NOTICE TO BIDDERS

ADDENDUM: TENDER B/SM 28/21: UPGRADING OF THE WEMMERSHOEK WASTEWATER TREATMENT WORKS: PHASE 1

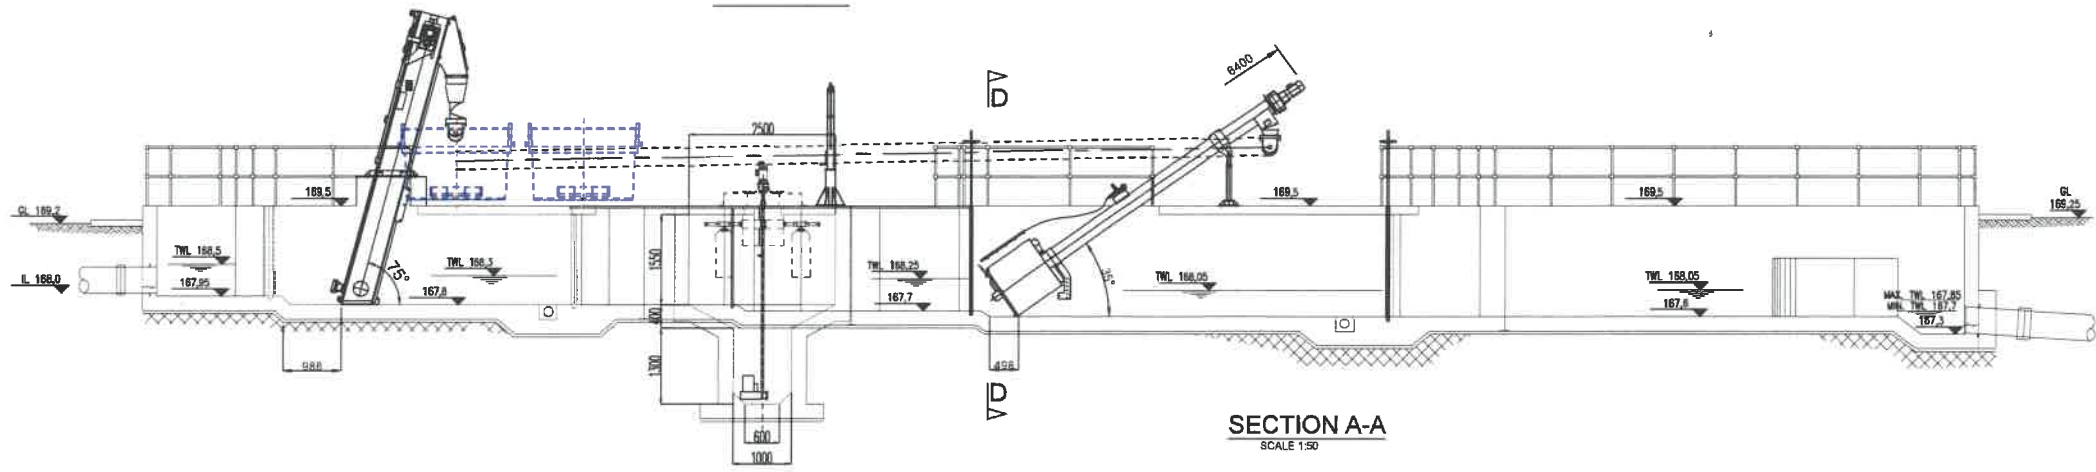
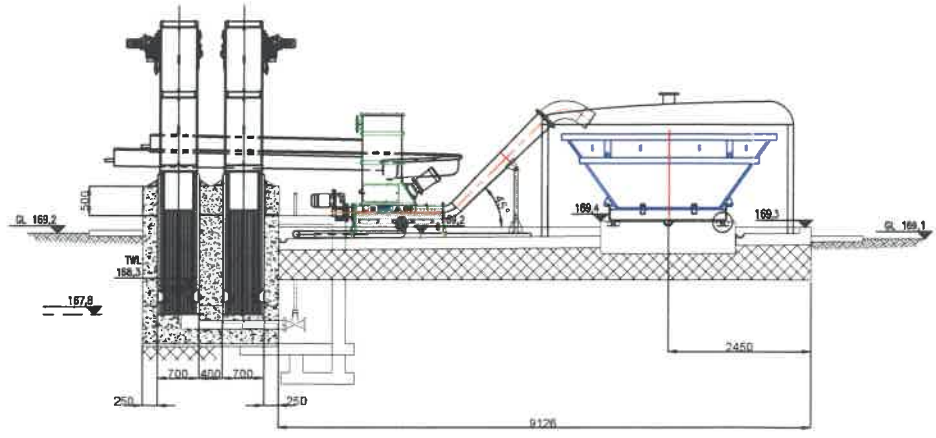
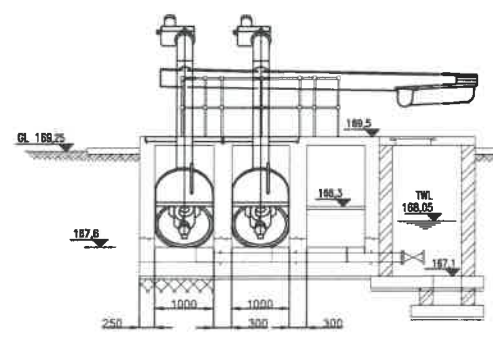
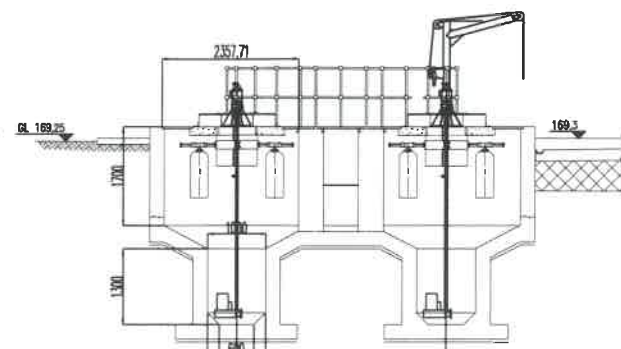
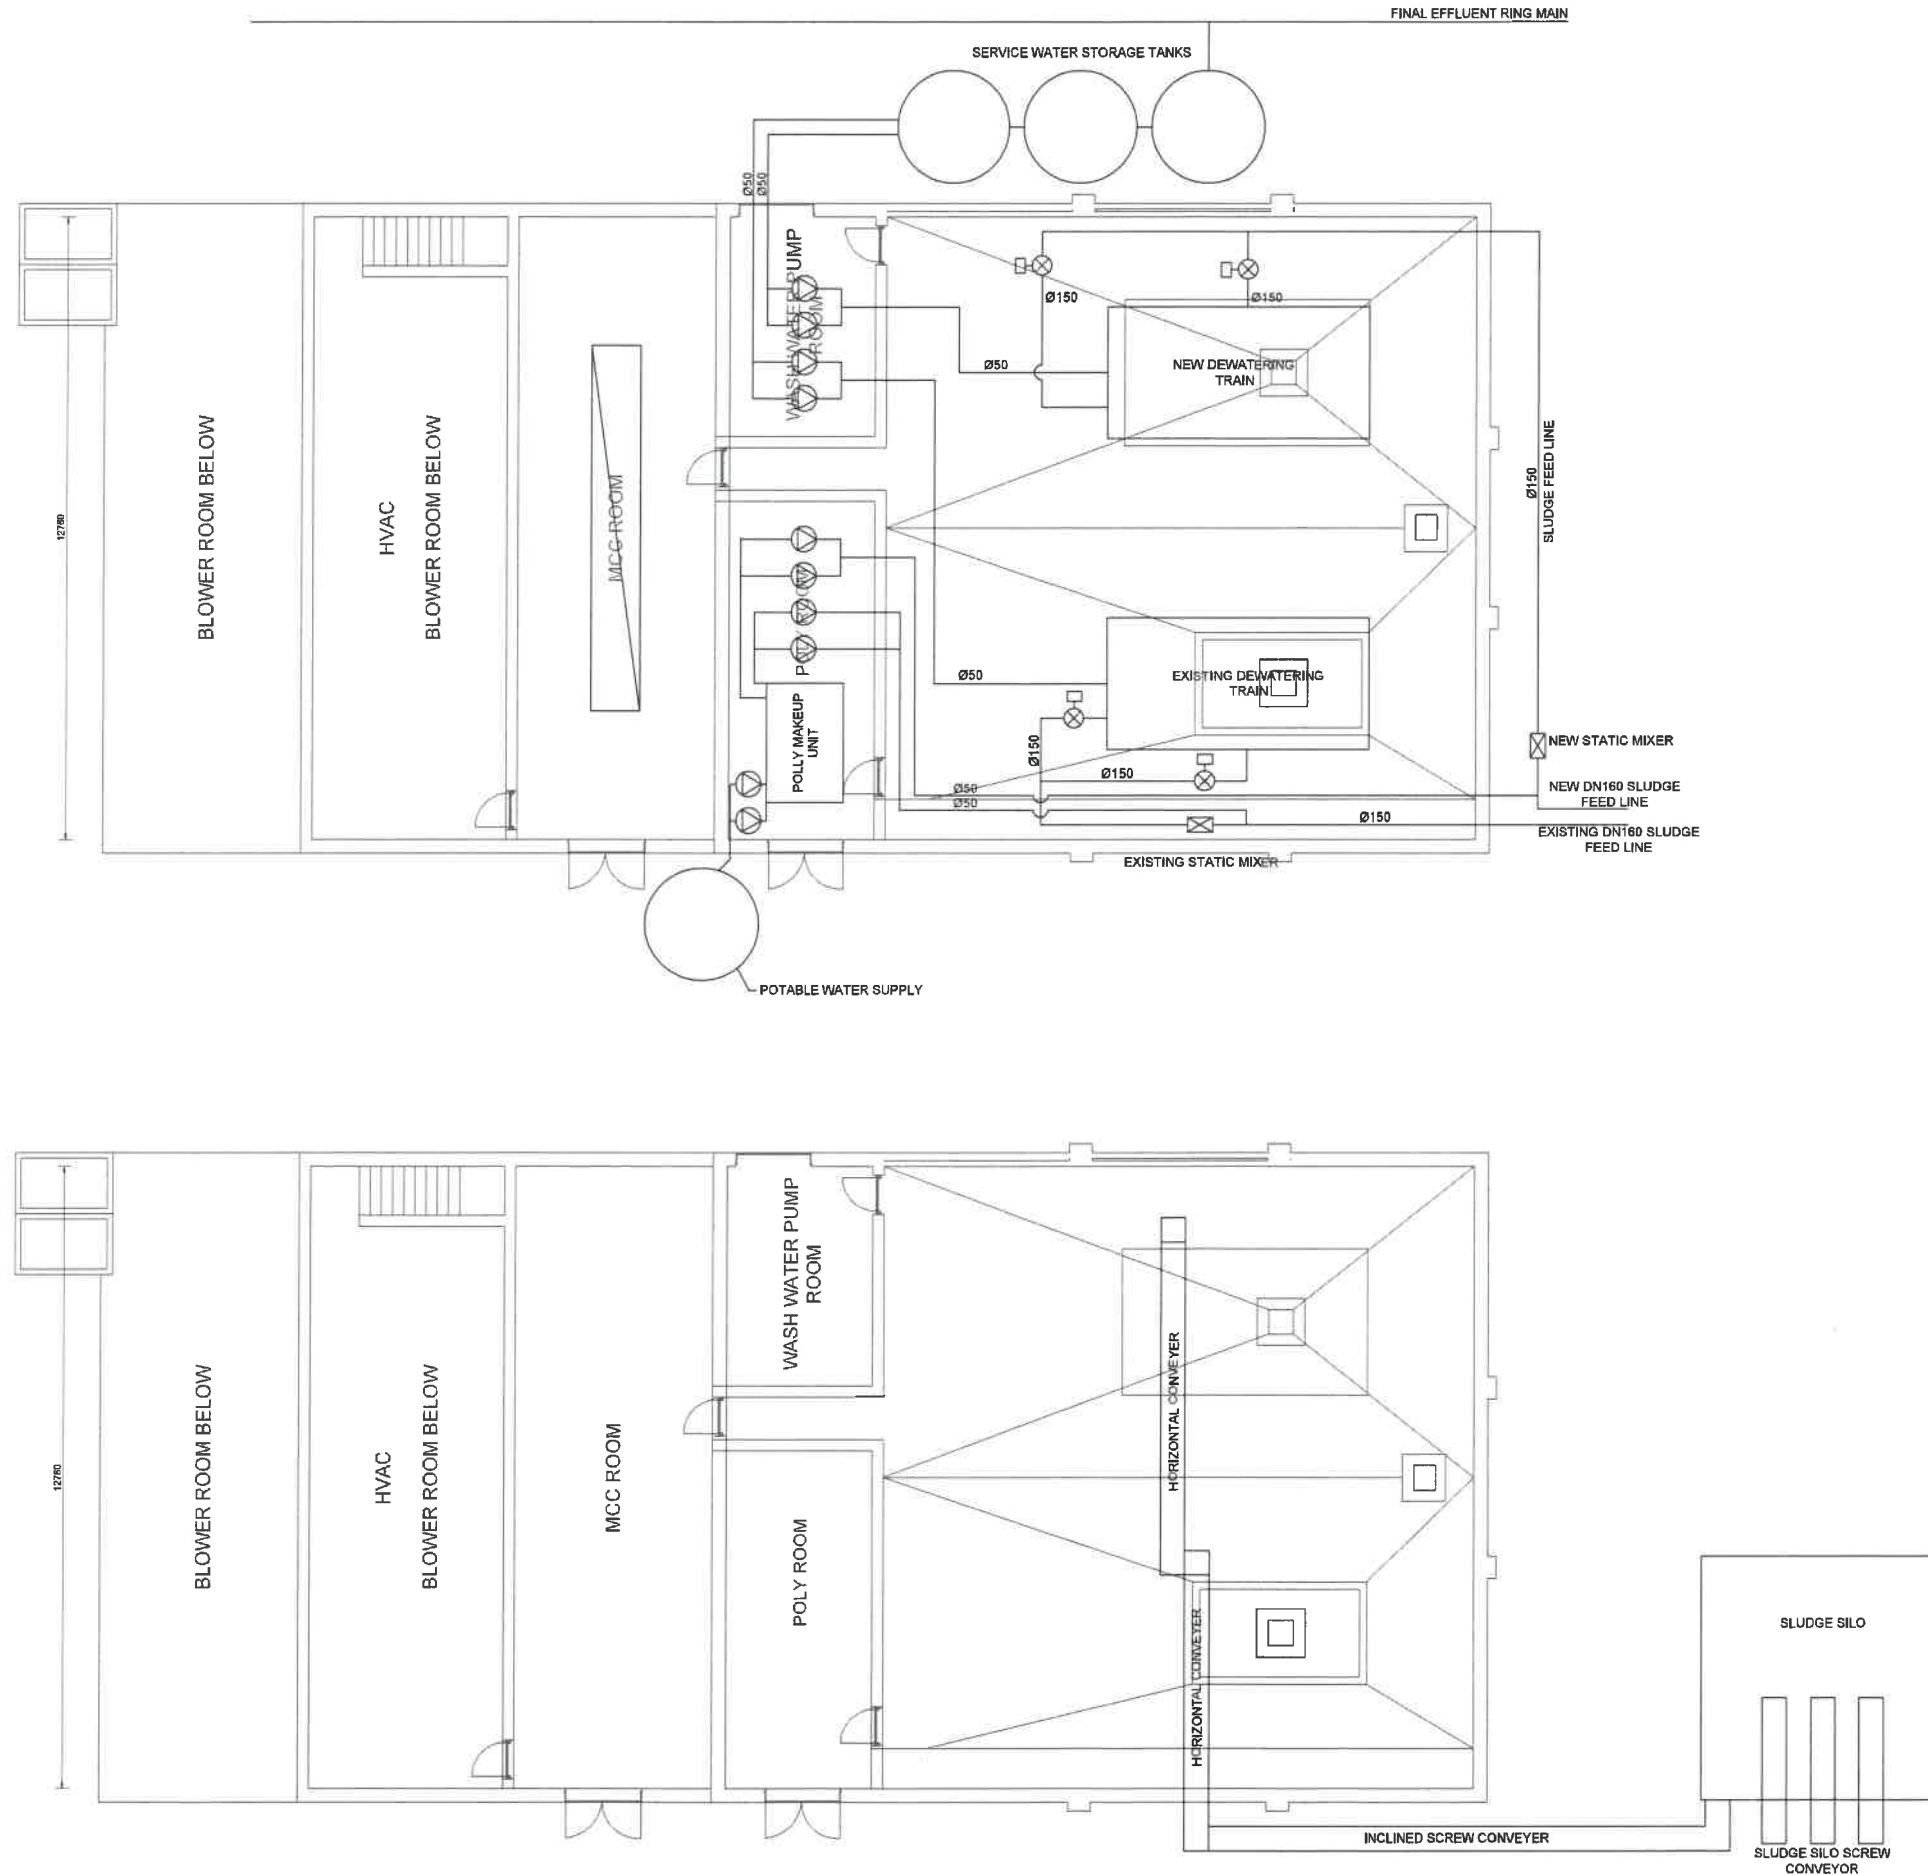
8. Add Attached Drawing ST1077/AB000/00: Existing Inlet Works to the Drawing List on page 206 and 362.

Question 1: Vortex degritter sectional drawings required.

Answer: Add Drawing ST1077/AB000/00 Existing Inlet Works to the Drawing List on page 206 and 362 with the attached drawing. — see point 8

DRAWING NO.
ST1077/M10-001

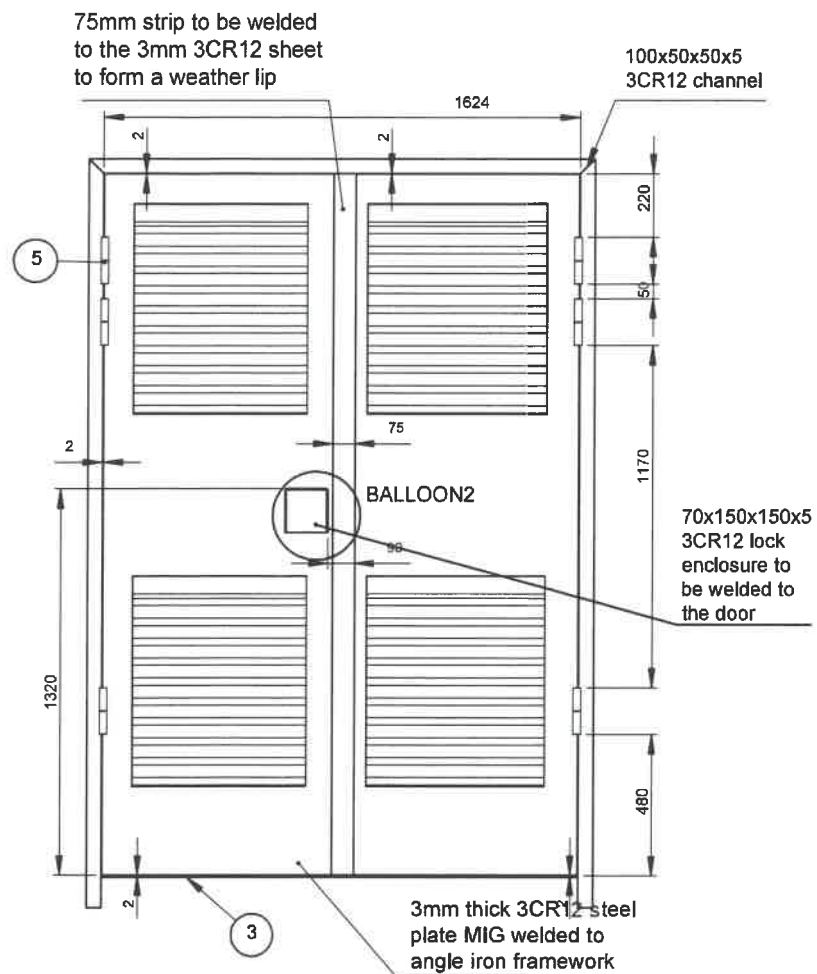
9. Replace drawing ST1077/M10-001/0 Wemmershoek WWTW – Belt Press Building Mechanical Layout with drawing number ST1077/M10-001 on page 206 and 362.

Question 3: Poly pump drawing layout required. Reference is made to a drawing in tender specification. Not on cd.

Answer: Replace drawing ST1077/M10-001/0 Wemmershoek WWTW – Belt Press Building Mechanical Layout with drawing number ST1077/M10-001.

NE vs MERWE - PHENG - 20120187	DATE
CONTRACT NO. BSM 28/21	
FILE NO. ST1077/DRW/TENDER	
SCALE NTS (A3)	
DATE November 2020	
DRAWING NO. ST1077/G706/00-1

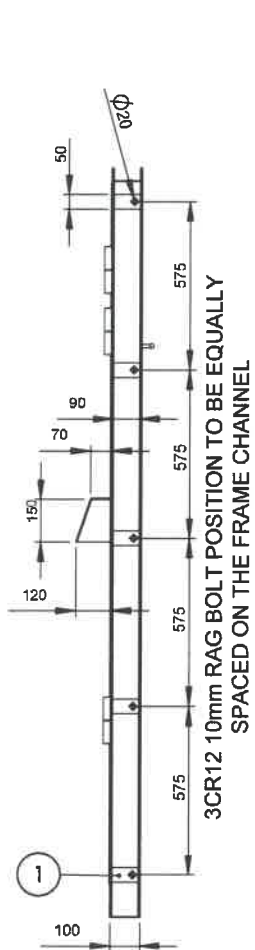
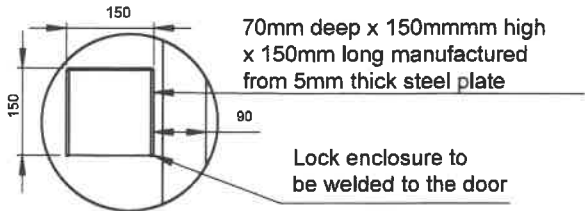
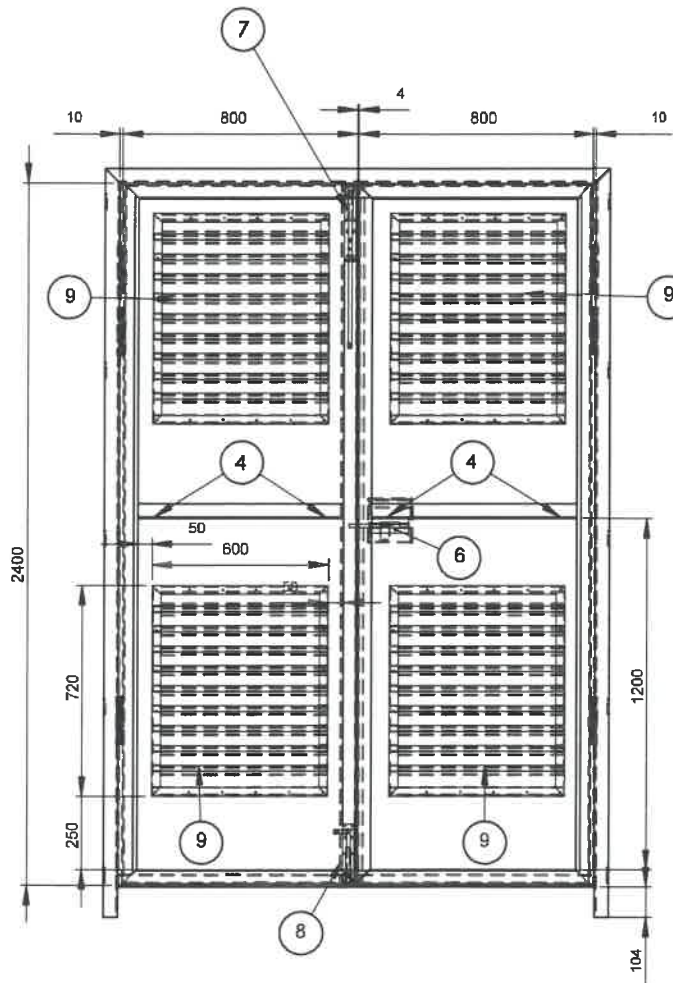
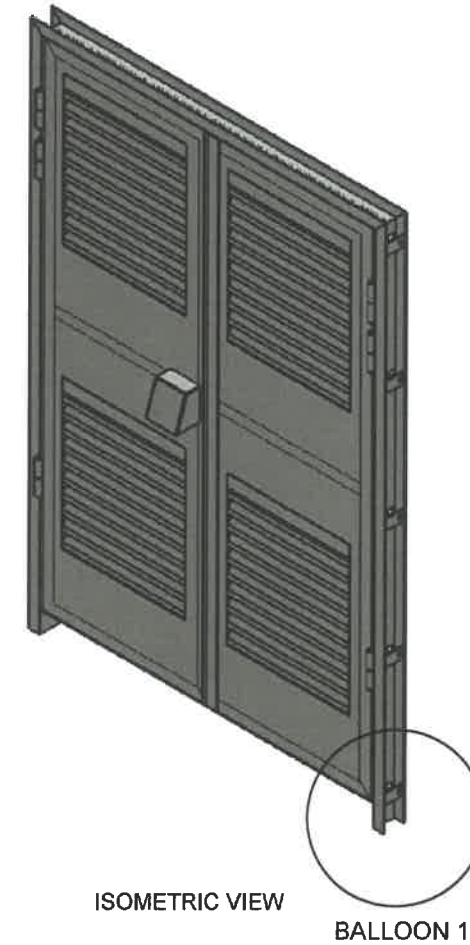
ITEM NO	PAYMENT	DESCRIPTION	UNIT	QTY	RATE	AMOUNT	
						R	c
C2.9.2		Supply and install doors, gates complete with frames and all fittings as per drawings and specifications:					
		Supply and HDG Steel door (door frame to be 1900mm high x 2500mm wide standard heavy duty steel double door with Louvres, rebate for 280mm wall) Item to include all associated ironmongery (hinges, bolts, catches, cabin hooks, handles etc) and rubber door stops:					
C2.9.3		External 2500mm x 1900mm	No	3

3. Add drawing ST1077/G706/00_1, ST1077/G706/00_2 and ST1077/G706/00_3 to the Drawing List to read with Item C2.9.3 External 2400mm x 1600mm in the Bill of Quantities (Page 163).

ITEM NO	PAYMENT	DESCRIPTION	UNIT	QTY	RATE	AMOUNT	
						R	c
C2.9.2		Supply and install doors, gates complete with frames and all fittings as per drawings and specifications:					
		Supply and HDG Steel door (door frame to be 2400m high x 1600mm wide standard heavy duty steel double door with Louvres, rebate for 280mm wall) Item to include all associated ironmongery (hinges, bolts, catches, cabin hooks, handles etc) and rubber door stops:					
C2.9.3		External 2400mm x 1600mm	No	3
